# Design Review Board Agenda

**CITY OF MILL CREEK  
DESIGN REVIEW BOARD  
APPLICATION PL2018-0003**

**NAME OF PROJECT:** The Learning Experience (TLE) – Commercial Childcare Center

**PROPOSAL:** Review of building elevations, landscaping and monument sign

**Attachment 3 - Landscape Plan**

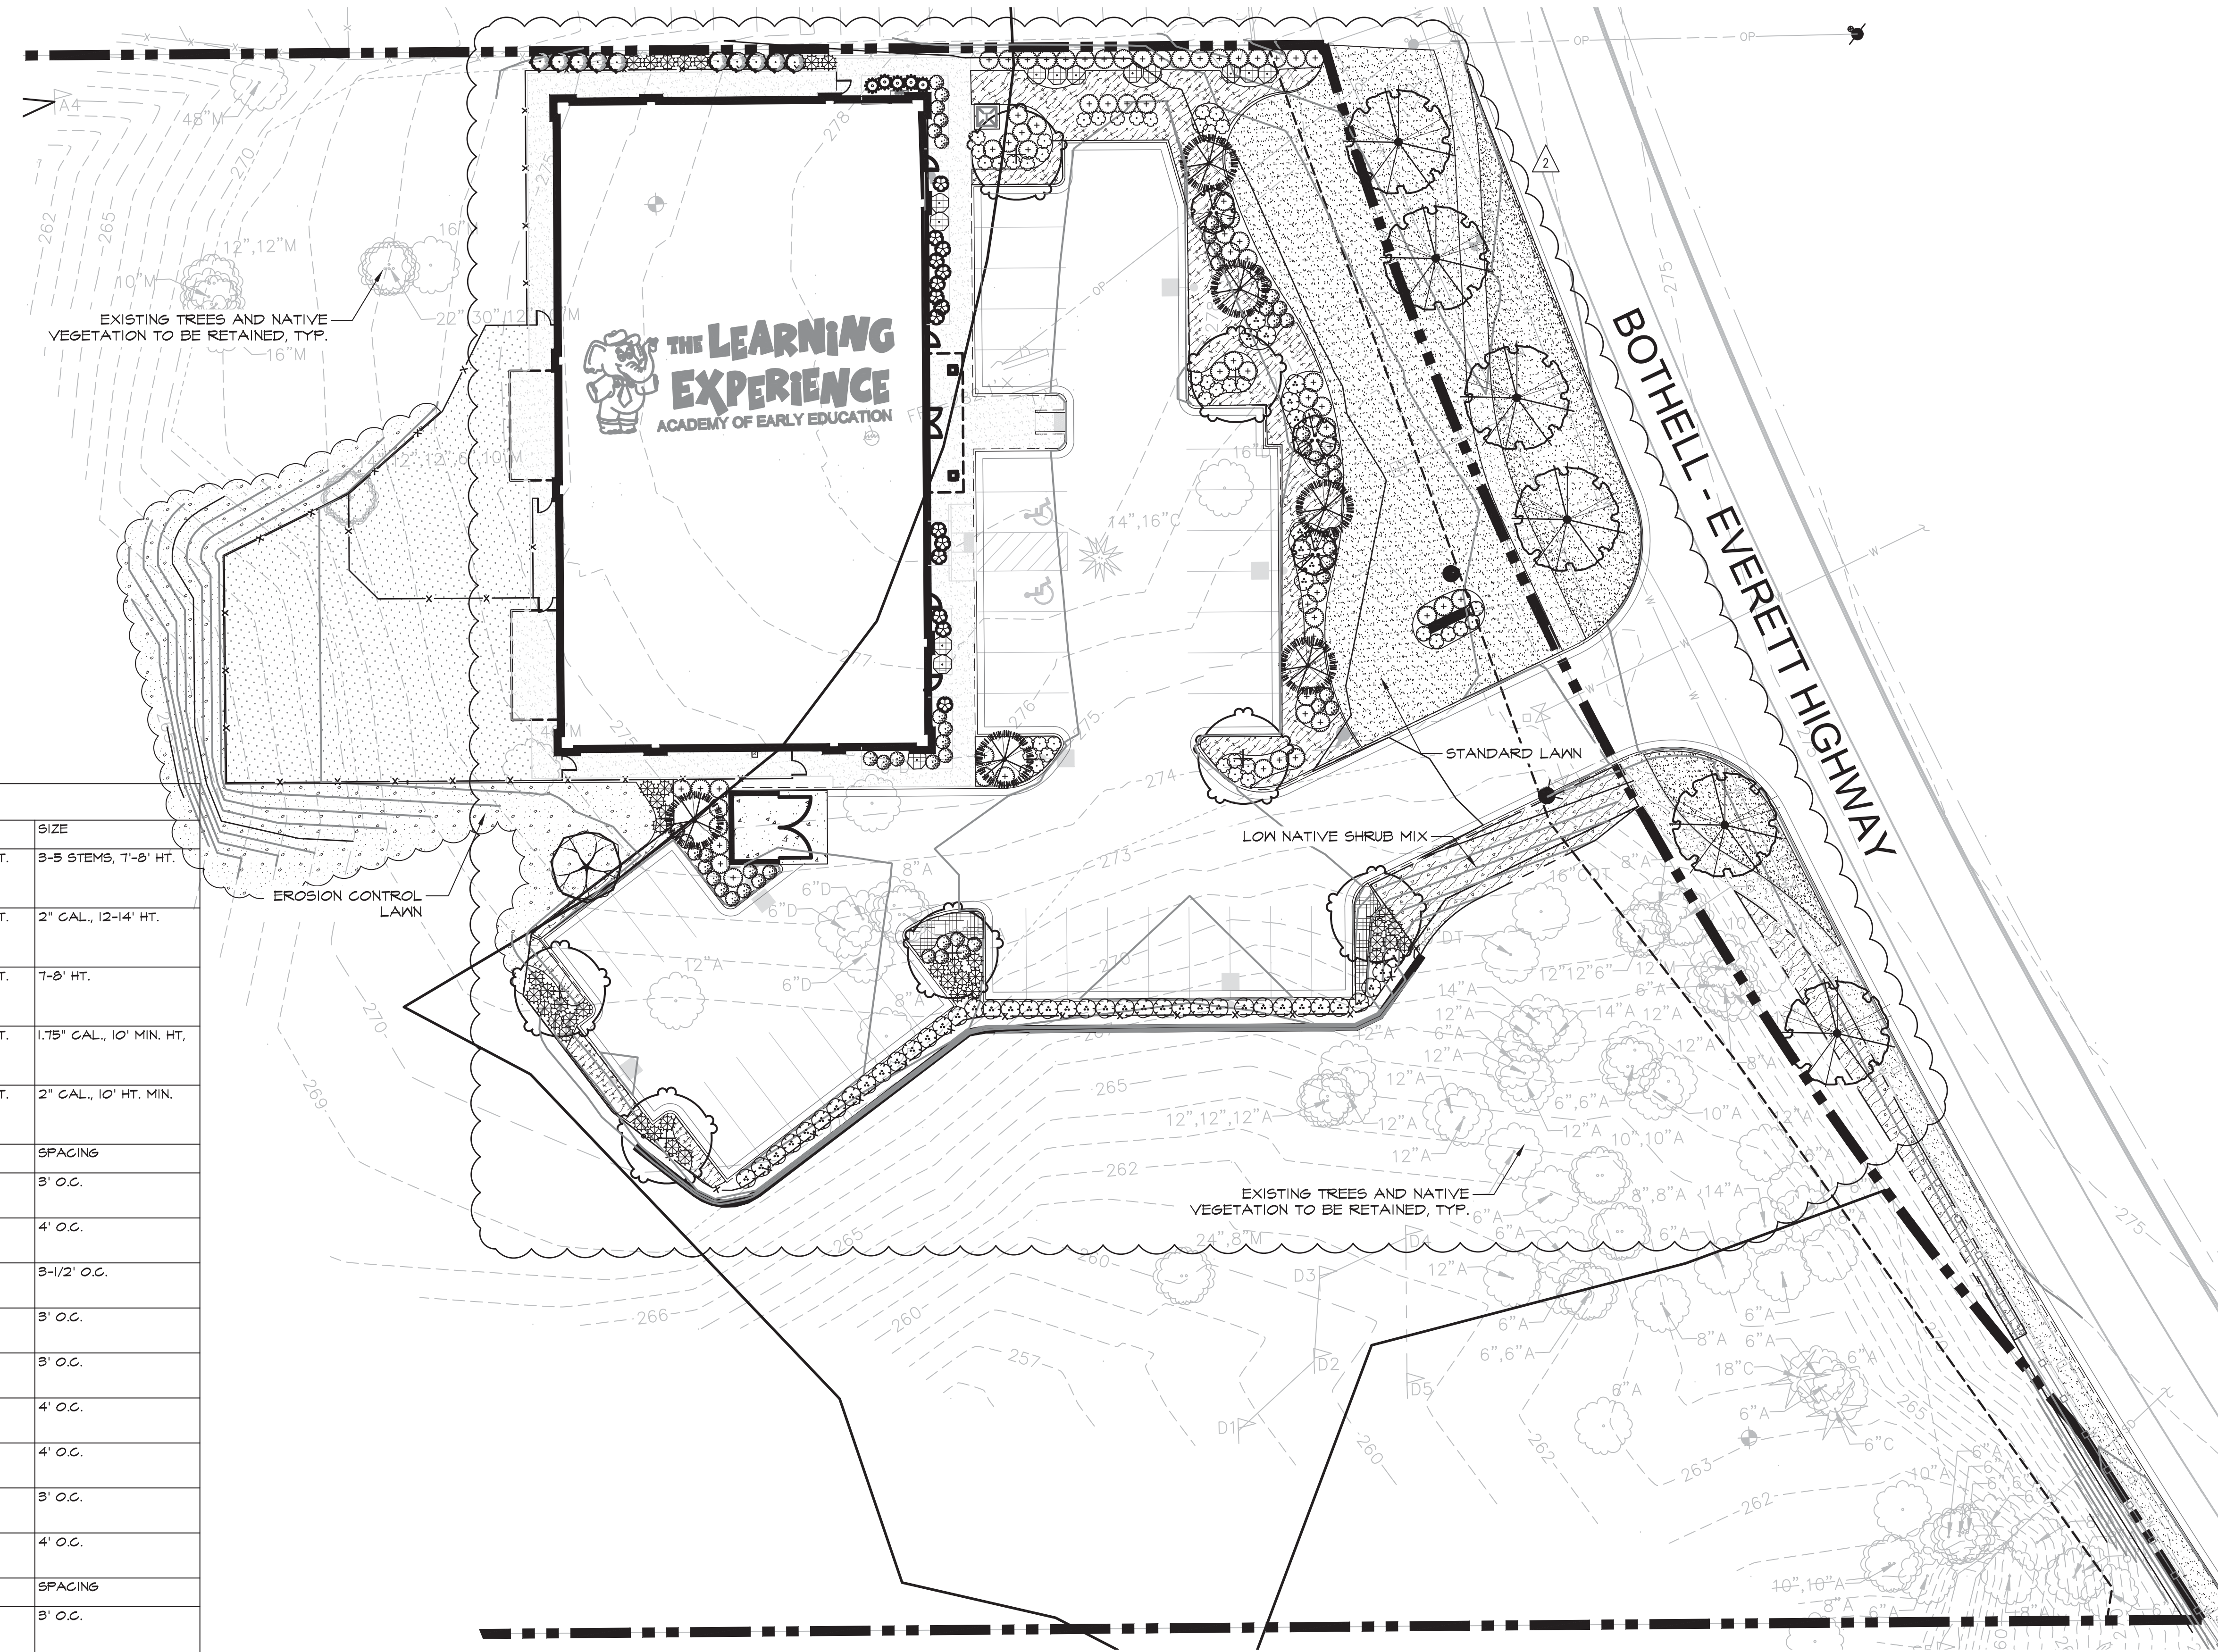
As suggested by the Design Review Board during the informal review, foundation plantings have been added around the base of the building to further enhance the front elevation. See **Attachment 3 – Landscape Plan**.

Staff is recommending three changes as follows:

- The Parkway Maple is known to have an issue with surface roots that compete with lawn and cause infrastructure damage; therefore, staff is recommending that the applicant select another species of street tree.
- Currently, David's Viburnum and Lemon Princess Spirea are proposed around the monument sign, which even when well maintained can have a height of 2 to 3 feet. Staff is recommending that the applicant select another shrub or groundcover that has a mature height of 1 foot or less so the landscaping does not obscure the monument sign.
- Currently the spacing on the groundcover (Winter Creeper and Kinnikinnick) is called out as 2 ½ feet on center. To achieve the coverage required by the Code, this should be 18 inches on center and the spacing on the low native shrub mix is called out as 3 feet on center and it should be 2 feet on center.

1. The building elevations, materials, colors, and design shall be as portrayed in the application.
2. Amend the landscape plan as follows:
  - Select another species of street tree, either from the Approved Street Tree list or a species that is approved by staff.

- Select alternate plantings around the monument sign with a lower mature height.
  - Show the spacing on the groundcover as 18-inches on center and the spacing on the low native shrub mix as two feet on center.
